# Interface to MAC and impact on MPCP

802.3av Denver – July 2008

# State diagram from Clause 4 (802.3av D2.2)

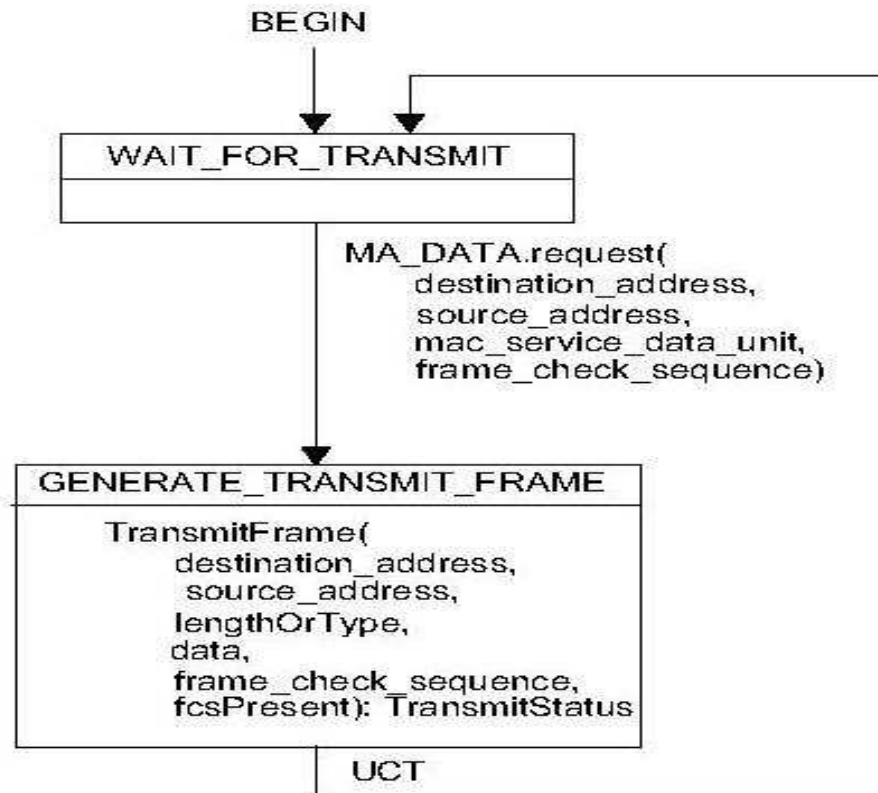
1. MA\_DATA.Request() has no duration
  - "round\_up((length+tailGuard) / 2)" must be added to the value of packet\_initiate\_timer
2. There is no carrier sense feedback to the MPCP state diagrams
3. MAC behaviour is incorrect if a second Request is started before the first Request is complete
  - FEC\_Overhead() must back off the exactly correct amount (or possibly more)
